COMMUNITY DEVELOPMENT DEPARTMENT
80 Columbia Avenue ♦ Marysville, WA 98270 ♦ (360) 363-8100

Re: Soper Hill Station – *Technical Review 1*
PA22030

After preliminary review of the above referenced proposal, the Planning Division has the following comments:

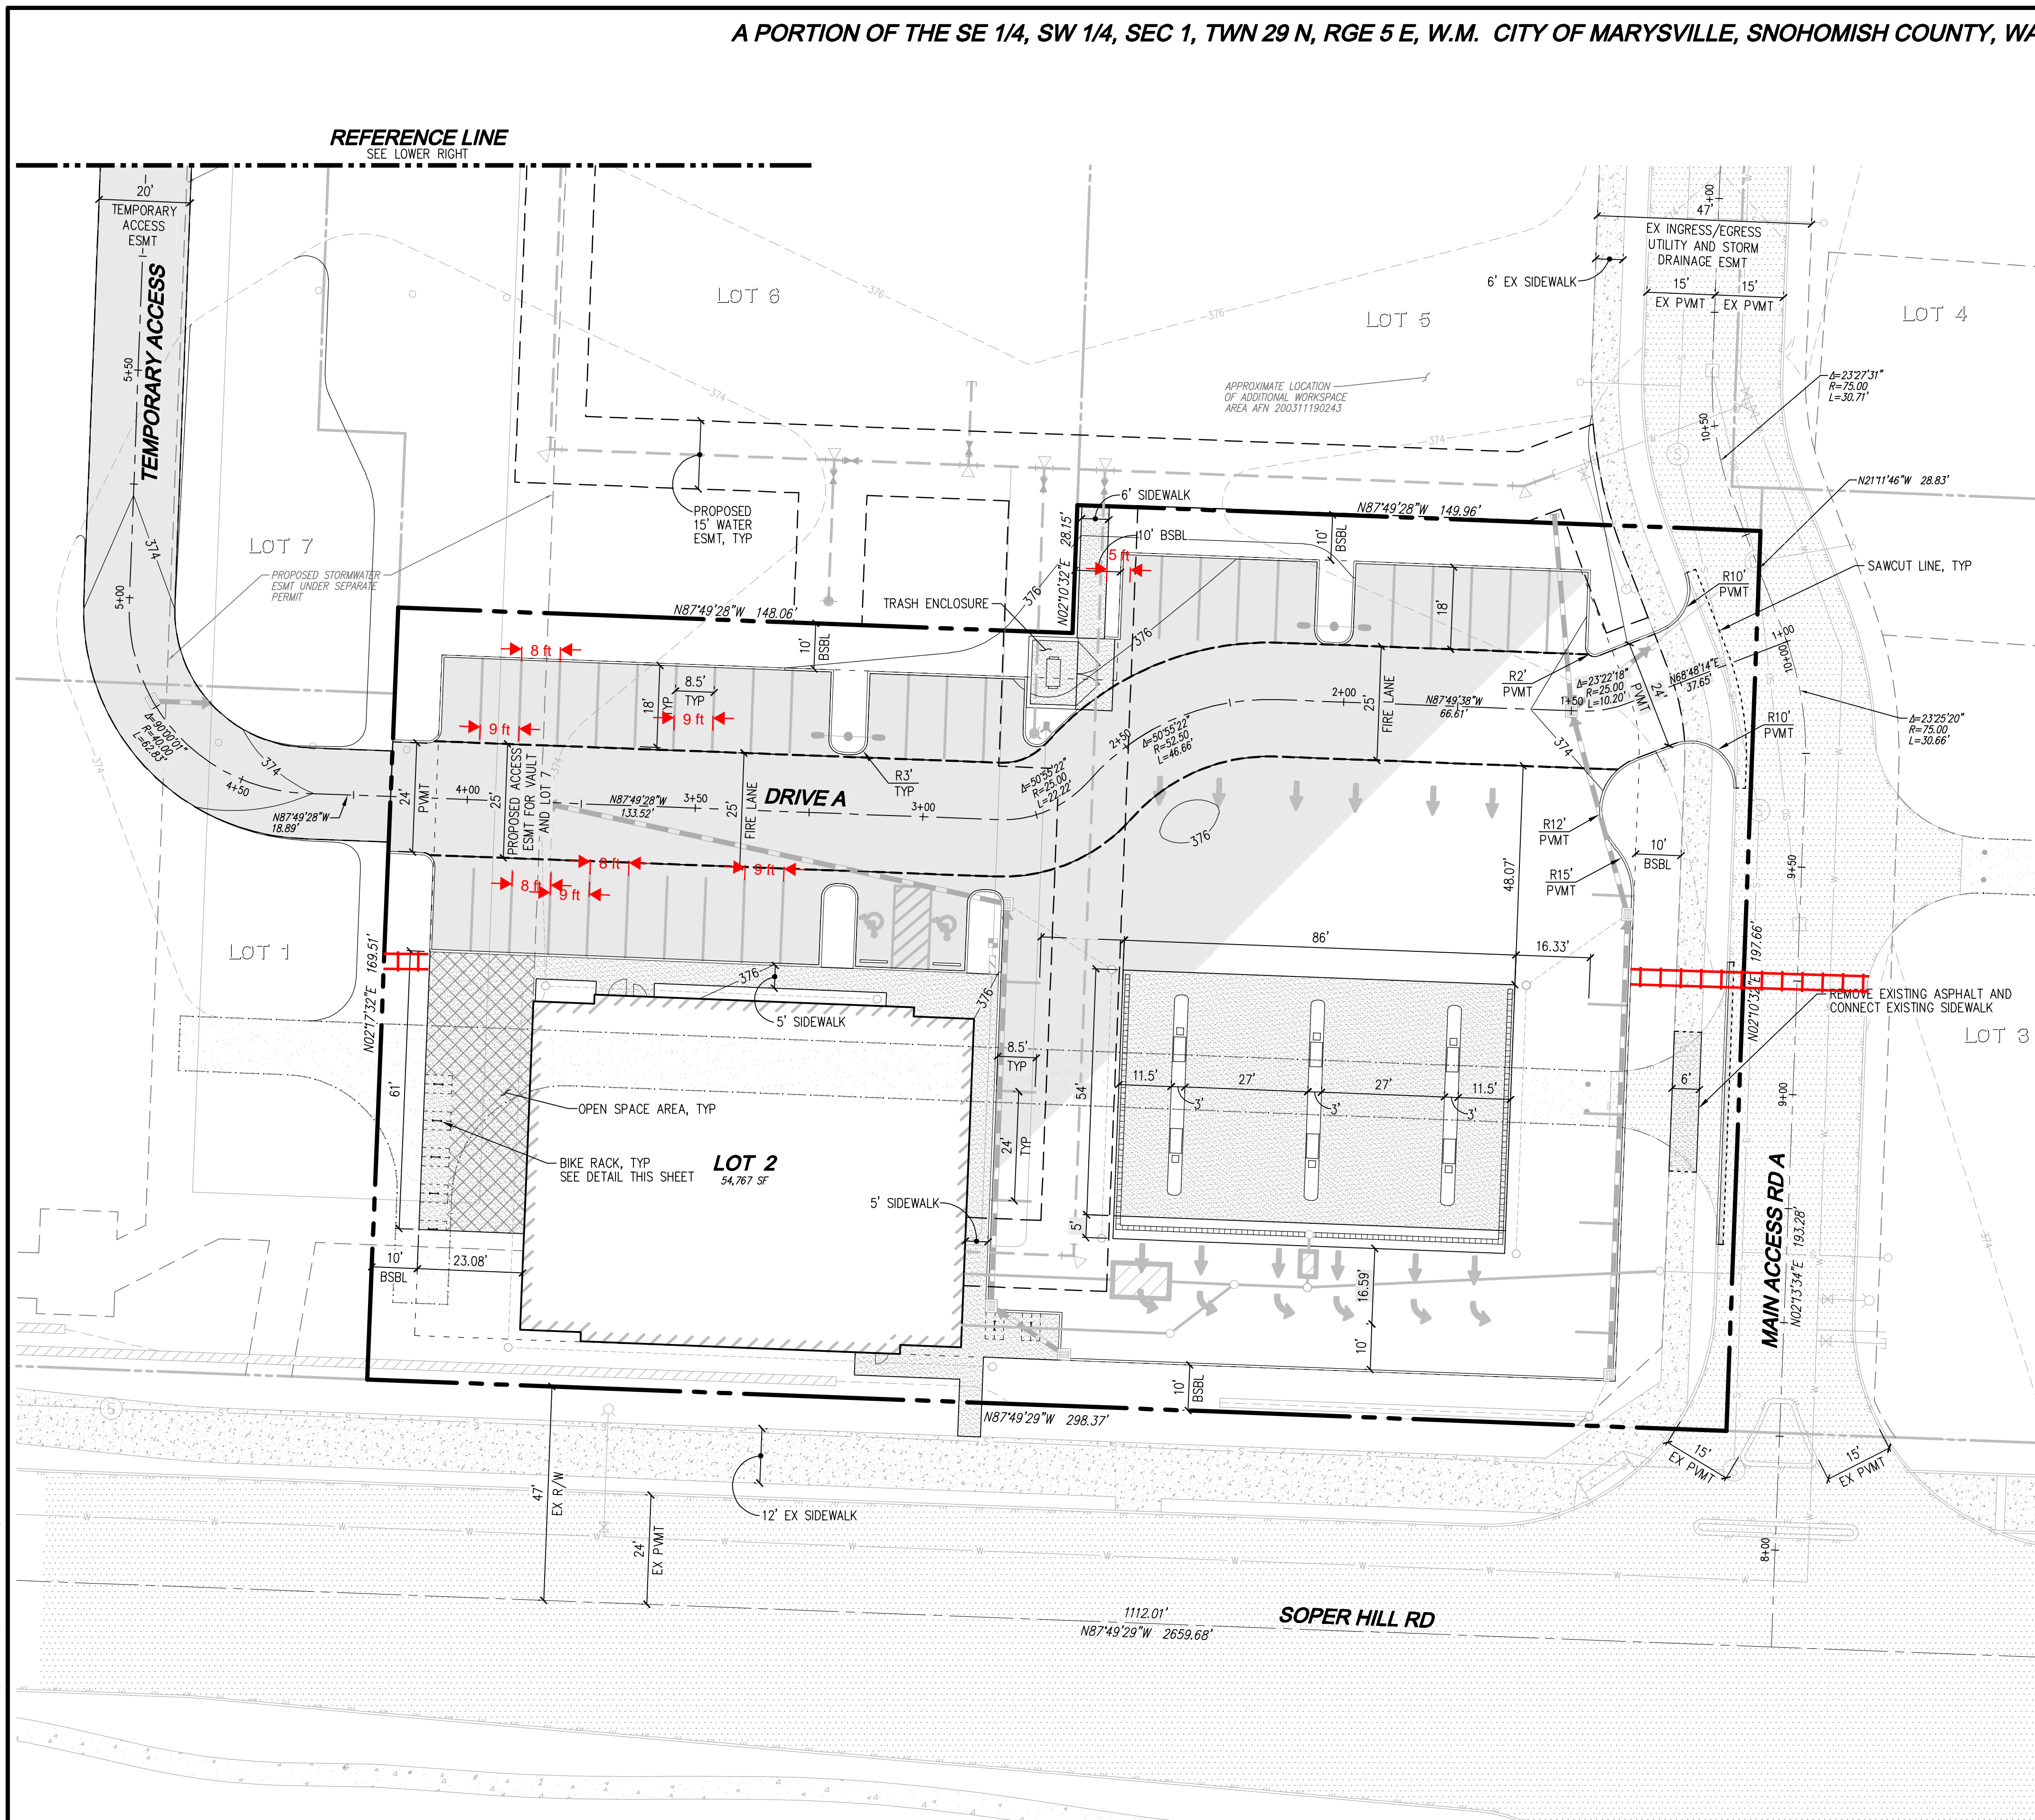
4. Amend Sheet SP-02, as follows:
 - a. Provide impervious surface calculations;
 - b. Provide an auto-turn exhibit with the formal land use application to ensure adequate circulation for both patrons and fueling trucks. Additionally, the applicant shall be required to demonstrate how a fueling truck can safely navigate through the White Barn Center;

- c. Add a minimum 5’ pedestrian pathway from the proposed open space area to Lot 1;
 - d. Provide a pedestrian connection from Lot 2 across the Main Access Drive to Lot 3. Consider potential development of Lots 3 & 4 for location of pedestrian connection;

- e. Amend the parking calculations to include building SF and math for calculating the required number of spaces, similar to the project narrative;
 - f. It appears that some of the proposed parking stalls measure 8’ in width. 8.5’ minimum required;

- g. B.4.1.a. requires a side and rear setback of 15’. It appears the building is only setback 10’ along the south property line
 - h. F.1.1 requires a 30’ landscaping setback from Soper Hill Road and a 20’ setback is required from Road A when a parking areas and drive aisles are located

- i. F.2.4.a. requires service elements (i.e. solid waste disposal areas) to be located to minimize the negative visual, noise, odor, and physical impacts of the street environment, adjacent (on and off-site) residents or other uses, and pedestrian areas. The proposed location of the solid waste collection area will need to be relocated so that it is not visible upon entry into the site.

- j. A minimum 5' L4 landscape buffer is required at the end of the row of parking on the northeast portion of the parking area.
5. The following comments are related to required building design:
